DATE: December 16, 2019

SUBJECT: ADDENDUM #4 TO THE BIDDING DOCUMENTS FOR:  
**BID GROUP #8**  
**MASTER FACILITY PLAN IMPLEMENTATION**  
**COMMUNITY HIGH SCHOOL DISTRICT 99**  
**1436 NORFOLK STREET**  
**DOWNERS GROVE, IL 60516**

This addendum forms a part of the Bidding Contract Documents, dated November 20, 2019. Bidders must acknowledge receipt of this Addendum in the space provided on the Bid Form. Drawing revisions clouded and tagged throughout with delta 41.

Project Number:  
5274-42  
Drawn By:  
J.G.  
Sheet:

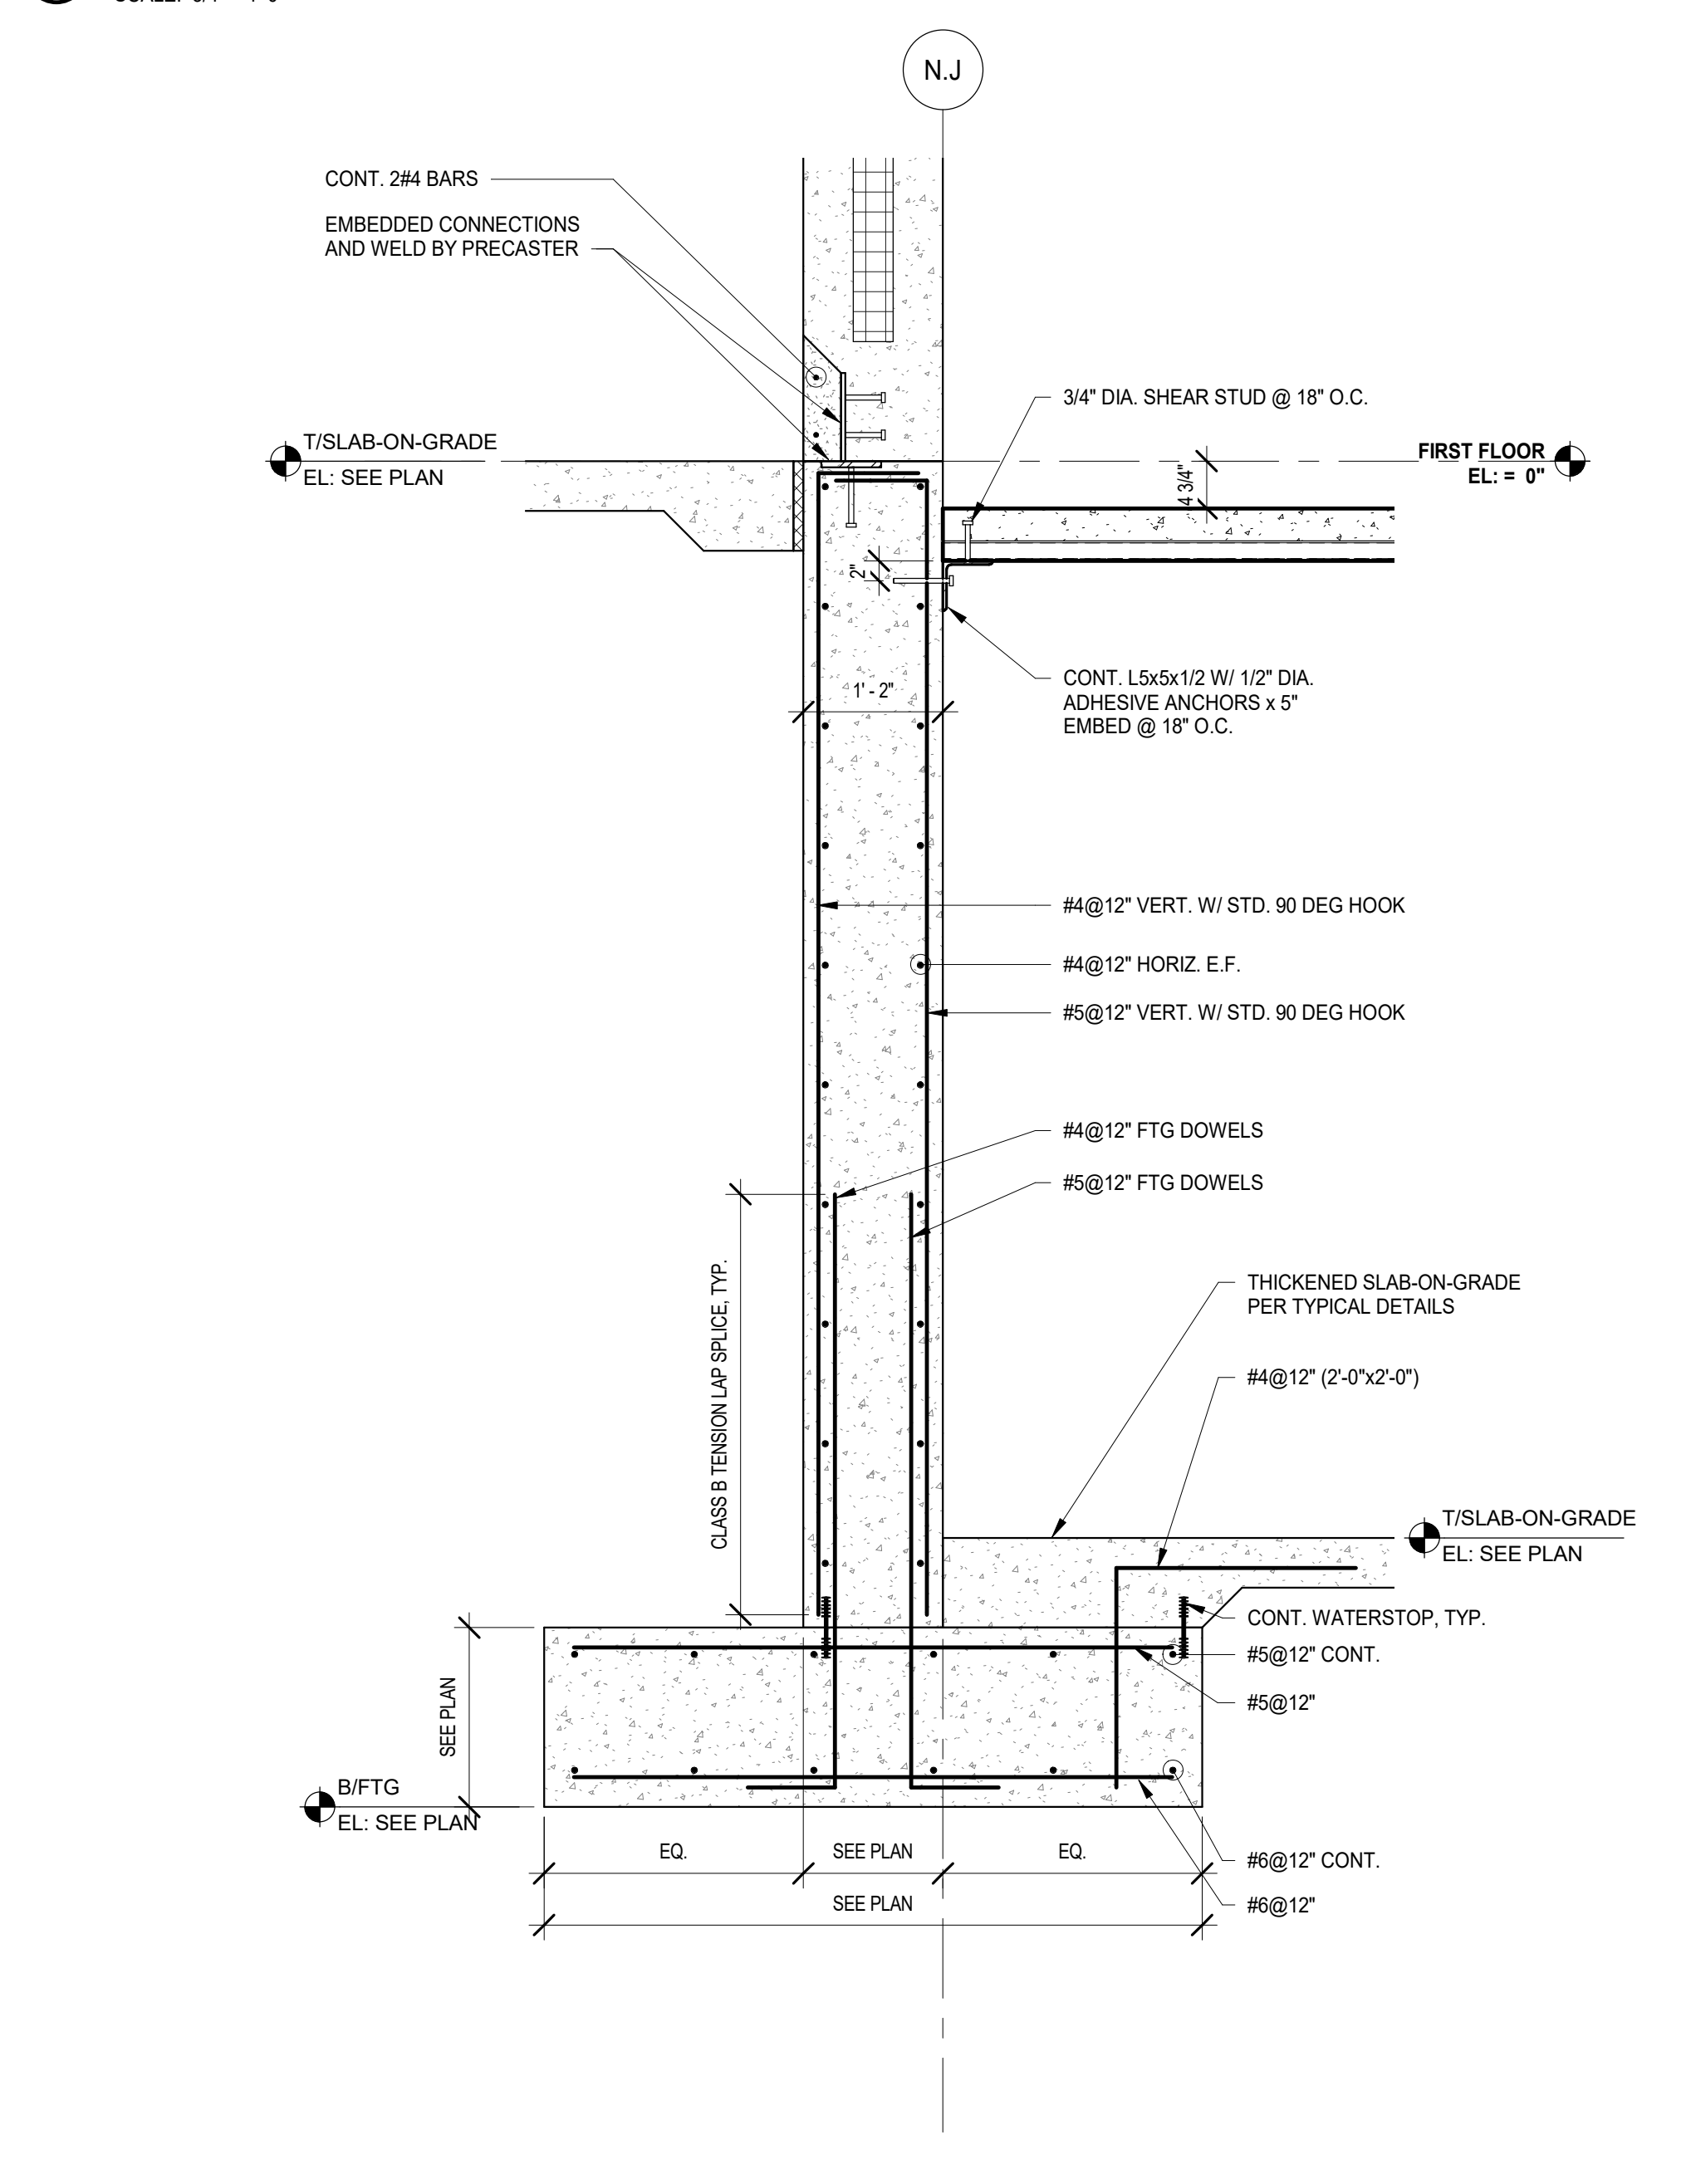
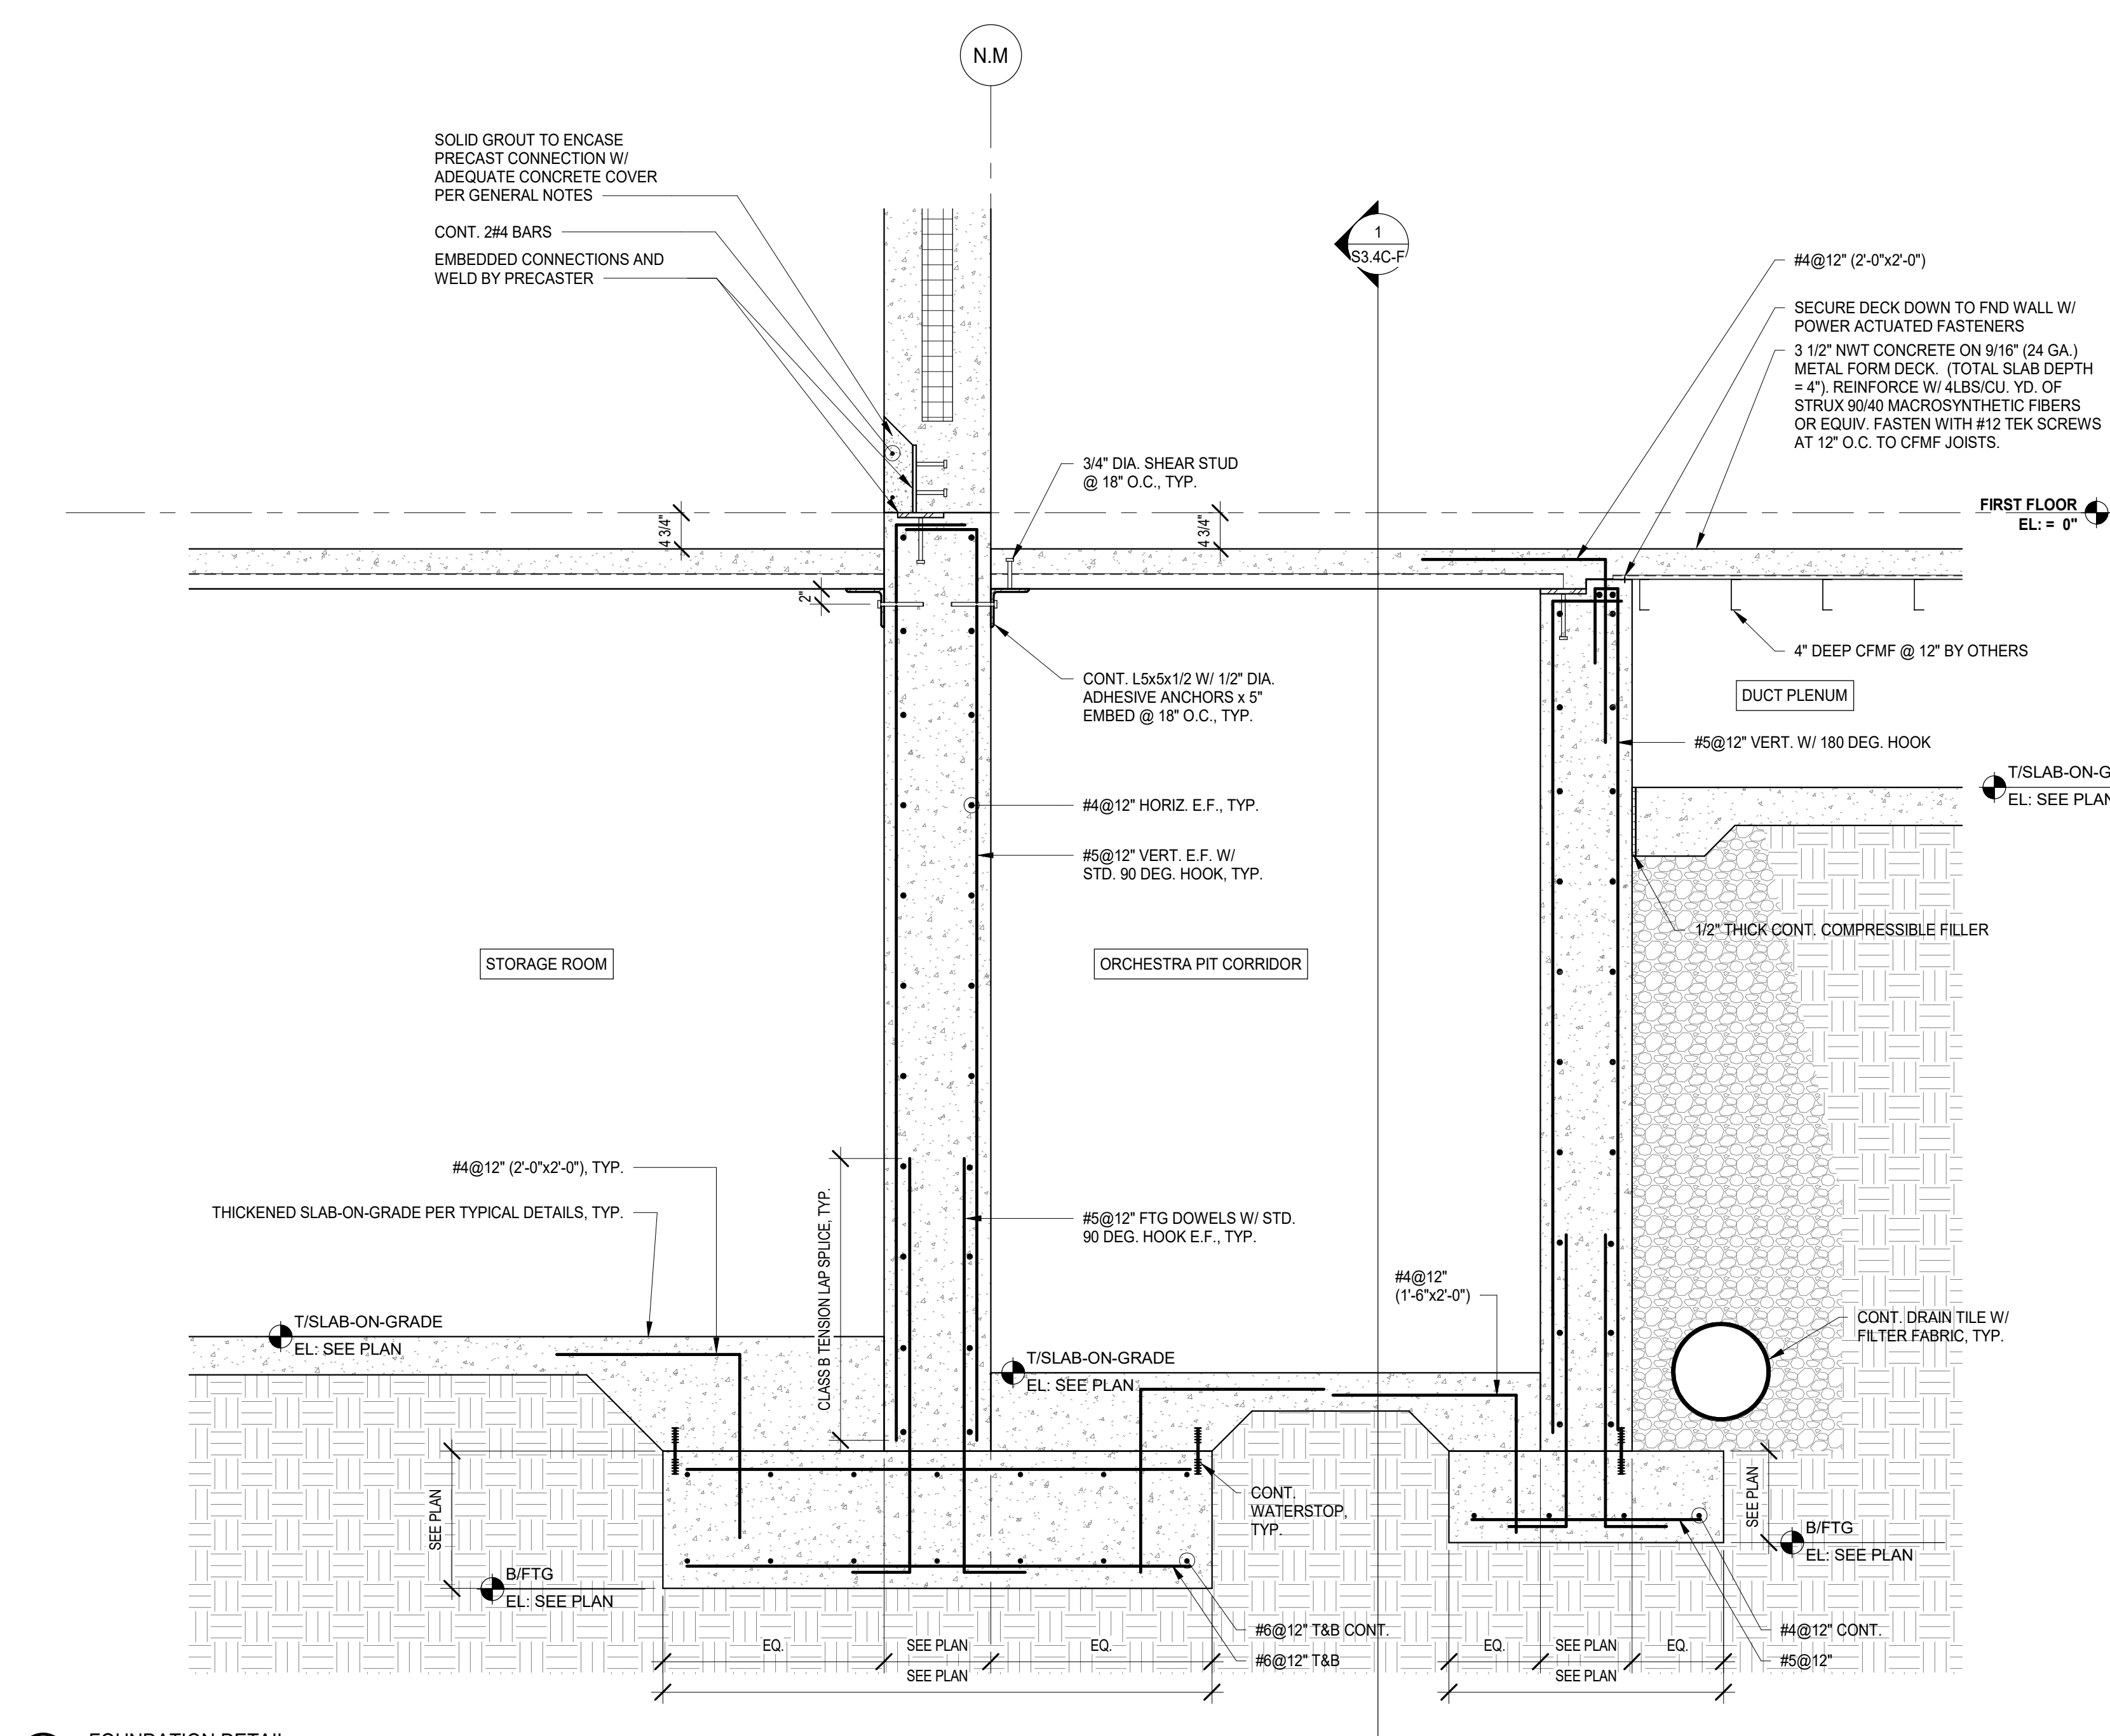
11. Sheet S2.7C-F ENLARGED PLANS (**Full size sheet issued**)
  - a. Plan 2: Added steel support for the spiral stair and revised existing framing and beam end reactions at precast wall supports accordingly.

2 FRAMING DETAIL  
SCALE: 3/4" = 1'-0"

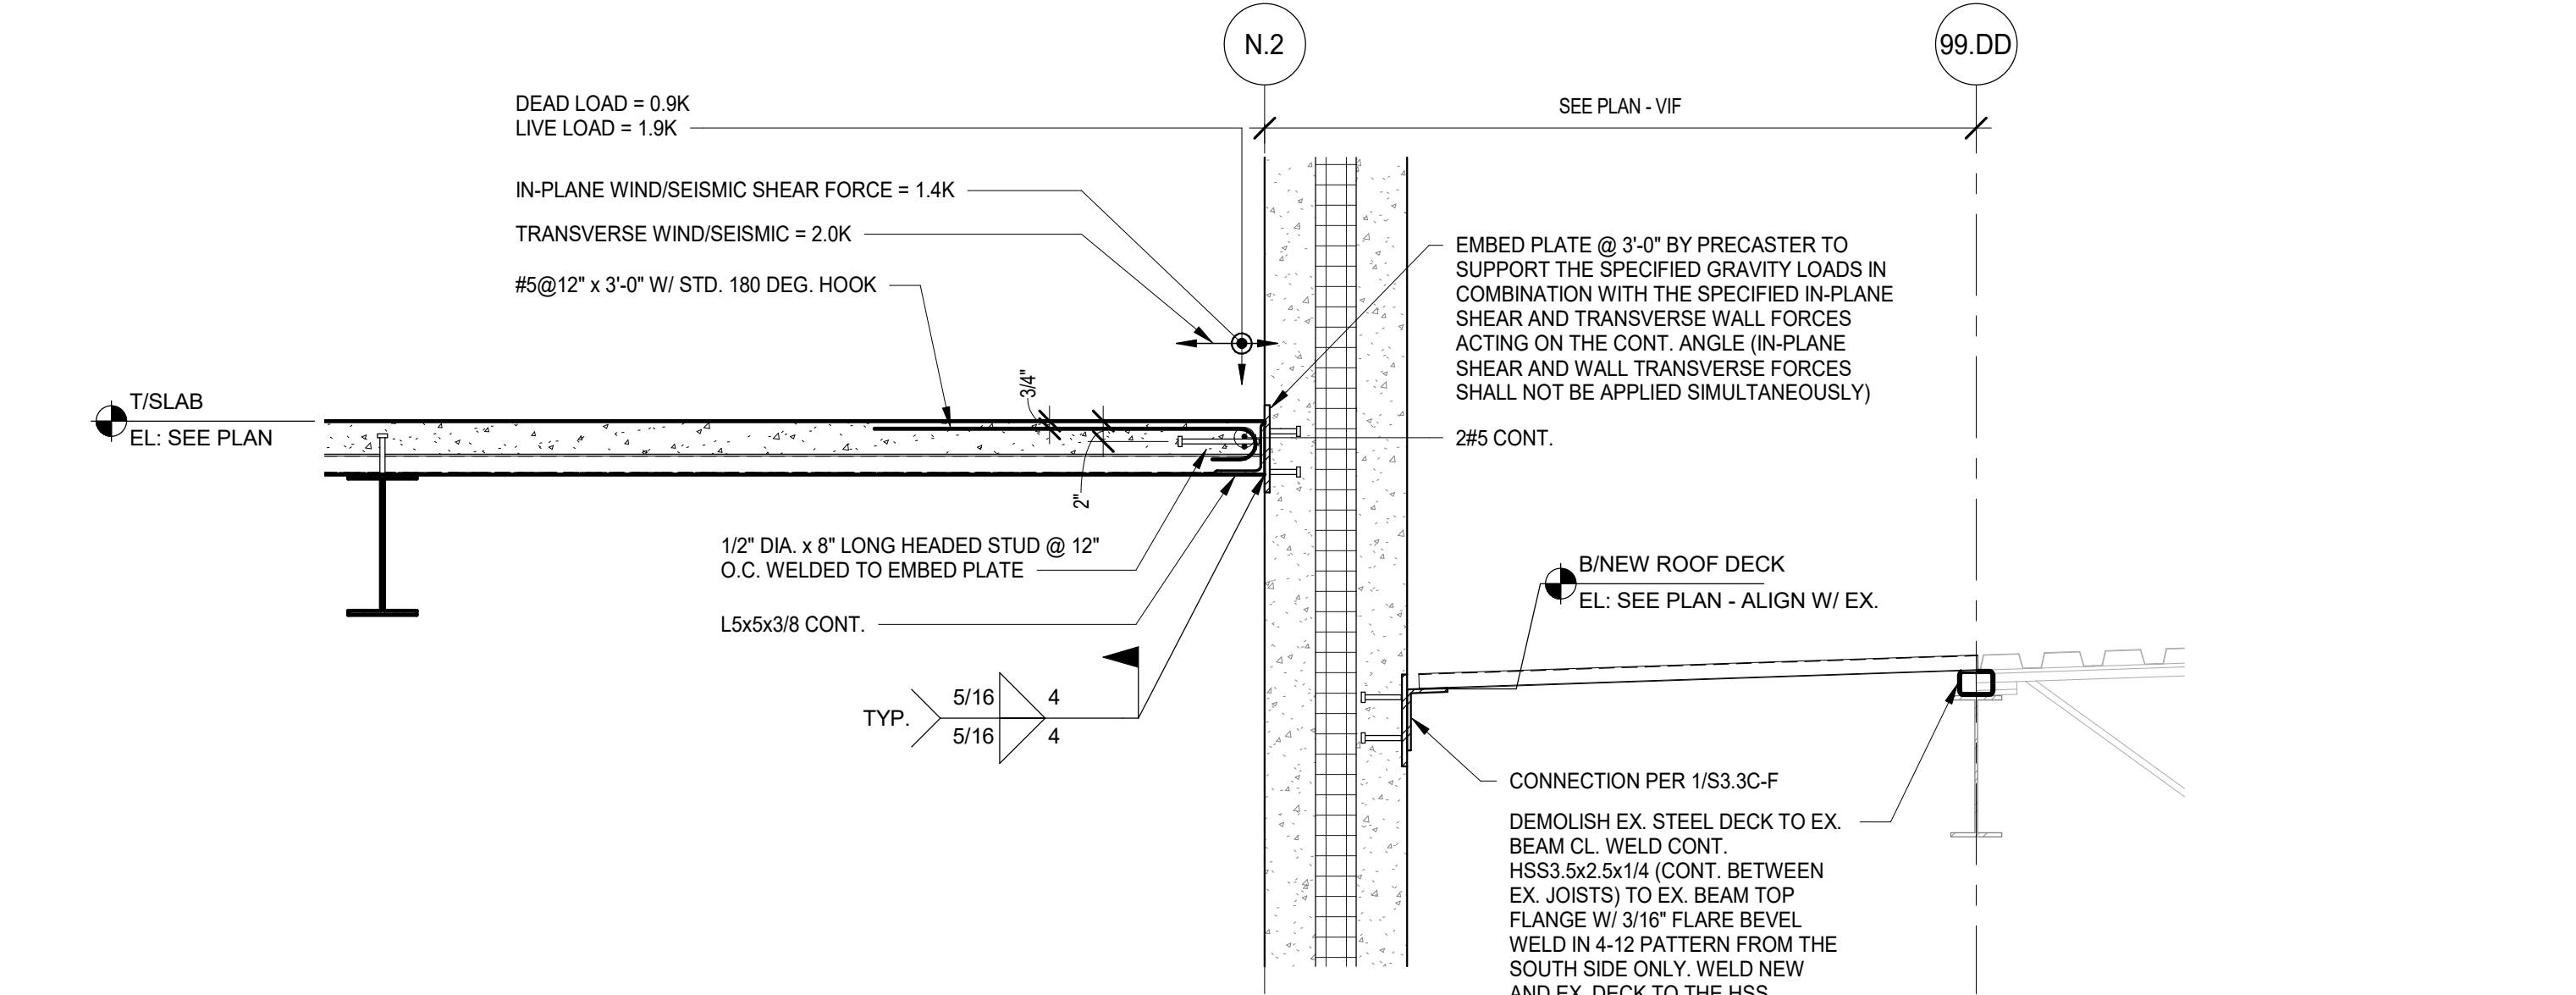
13. Sheet S3.6C-F NON-TYPICAL SECTIONS AND DETAILS (**Full size sheet issued**)
  - a. Revised details 2 and 10.
14. Sheet S3.7C-F NON-TYPICAL SECTIONS AND DETAILS (**Full size sheet issued**)
